Big Boss Corporation Ltd. (NEW)

Holding#30 Sharabo, Kasimpur, Gazipur

23th January 2018

Observations

Column Layout Plan

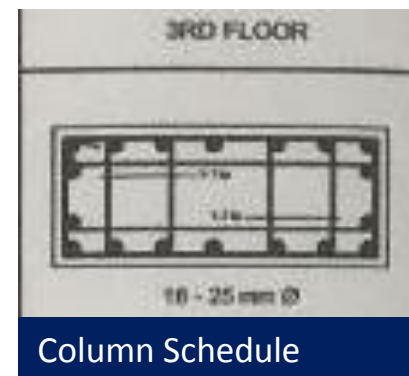
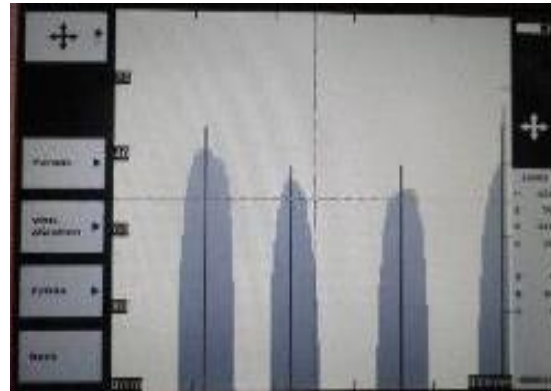
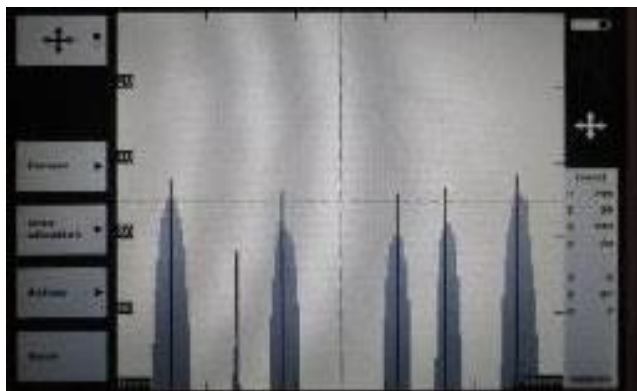
18 rebars are shown on the drawing in C-1 type column but during inspection 16 rebars were found by ferro scanning.

Column Layout Plan

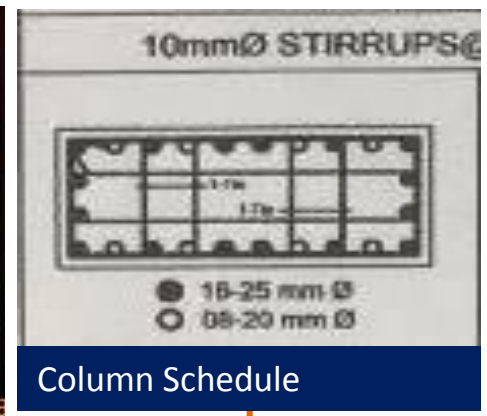
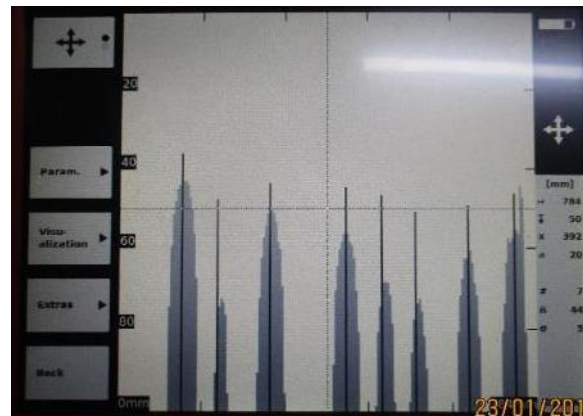
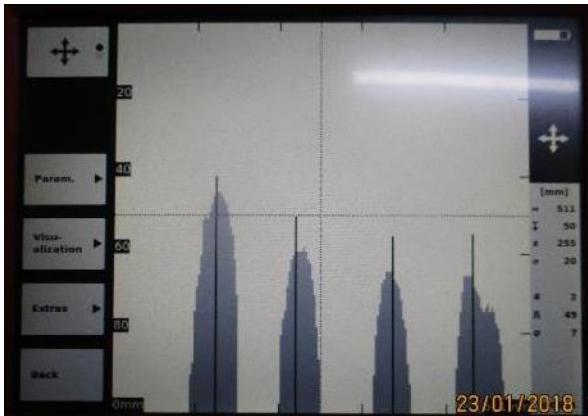
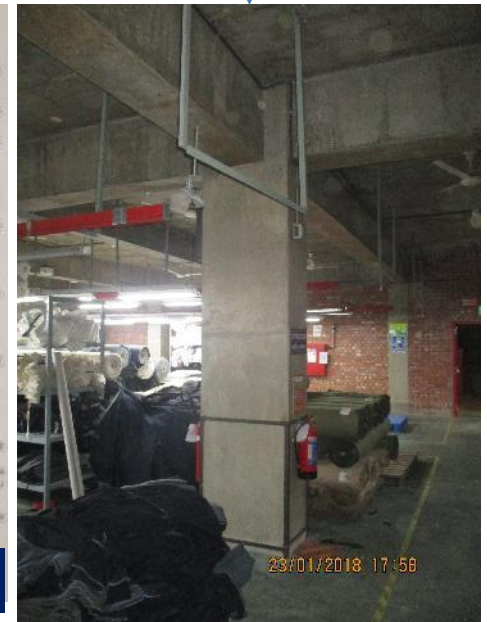
24 rebars are shown on the drawing in C-2 type column but during inspection 20 rebars were found by ferro scanning at 2nd floor.

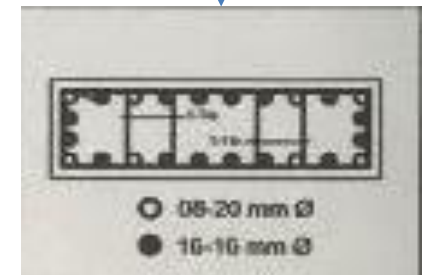
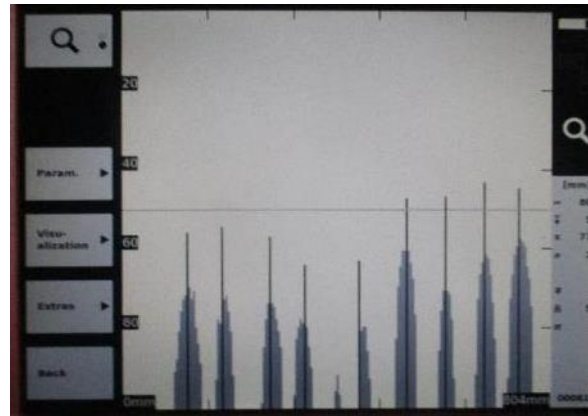
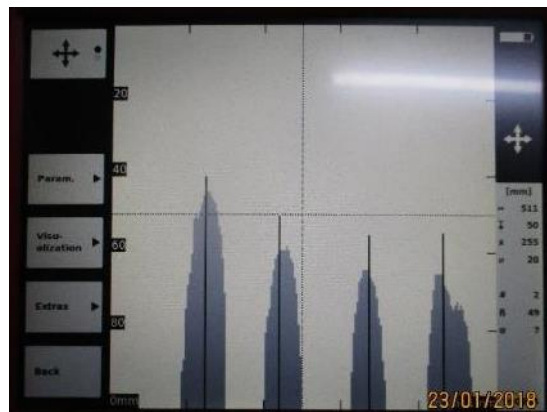
24 rebars are shown on the drawing in C-5 type column but during inspection 22 rebars were found by ferro scanning at 3rd floor.

Column Layout Plan

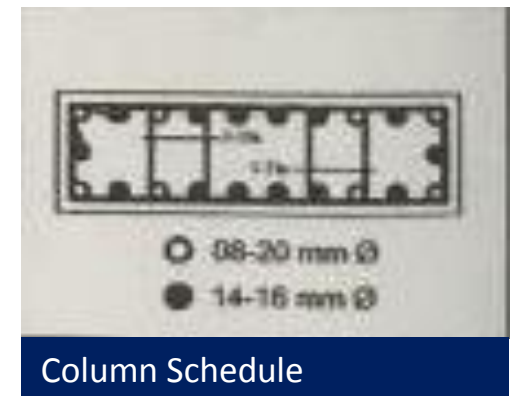
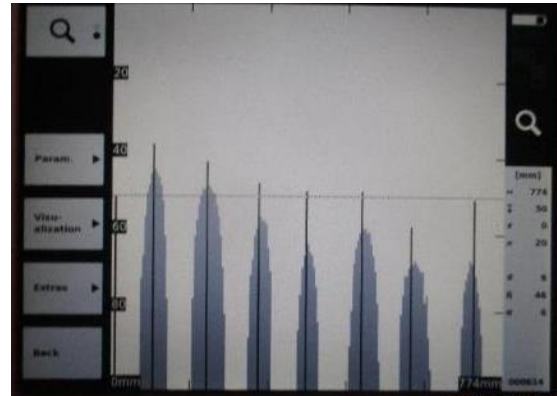
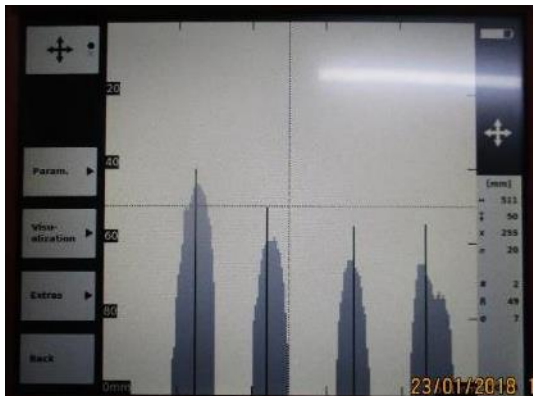
22 rebars are shown on the drawing in C-7 type column but during inspection 16 rebars were found by ferro scanning at 3rd floor.

Beam Layout Plan

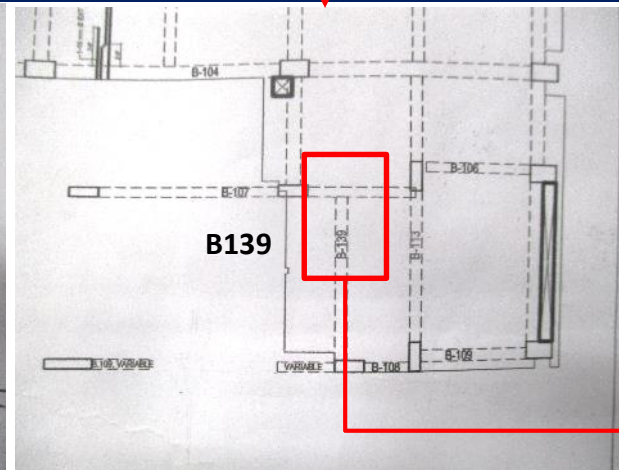
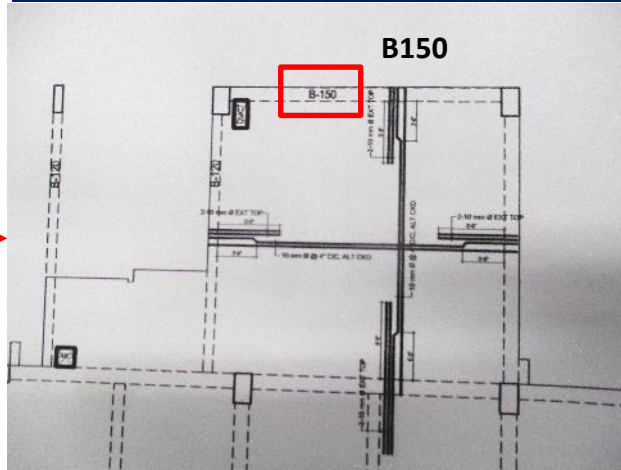
In beam layout plan, B-139 and B-150 type beams are shown but no section size and detail was found for these beams in provided drawing.

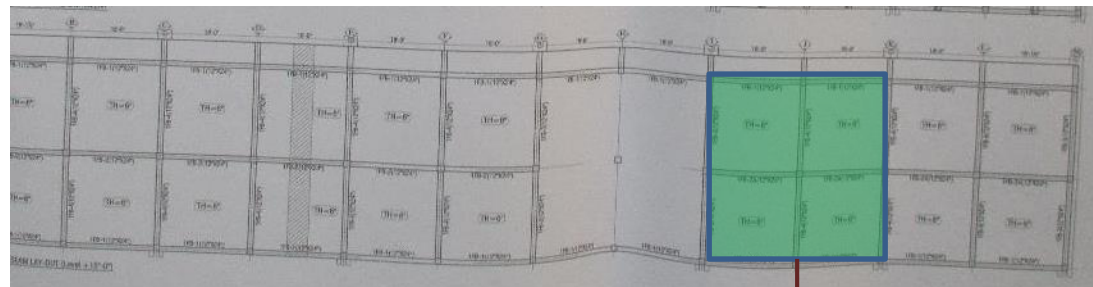
There is a staircase on the southern face of the utility building. Complete structural drawing of this staircase was not available in the provided drawing.

Double height ground floor location in as built drawings

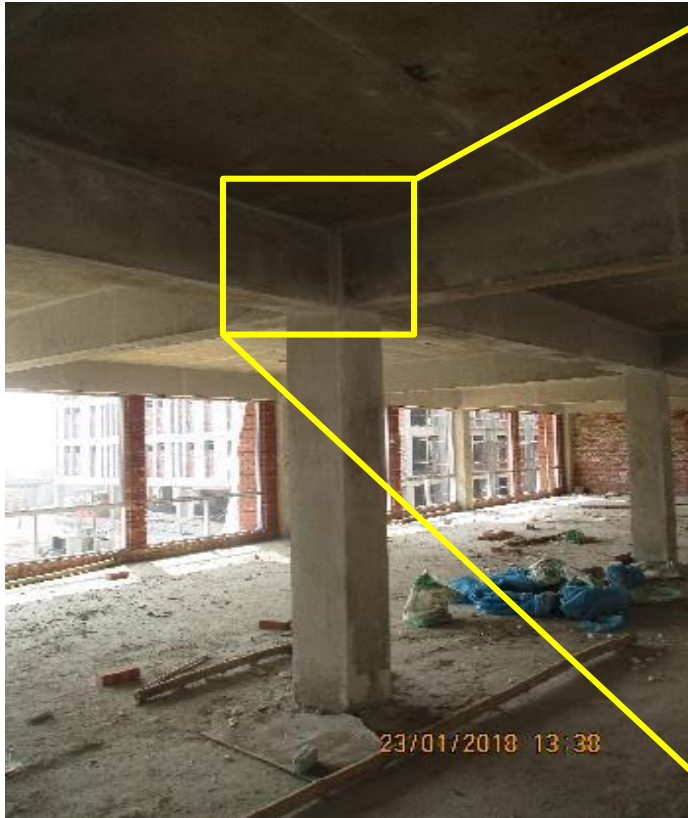
The location of double height column was not matched with the provided drawing.
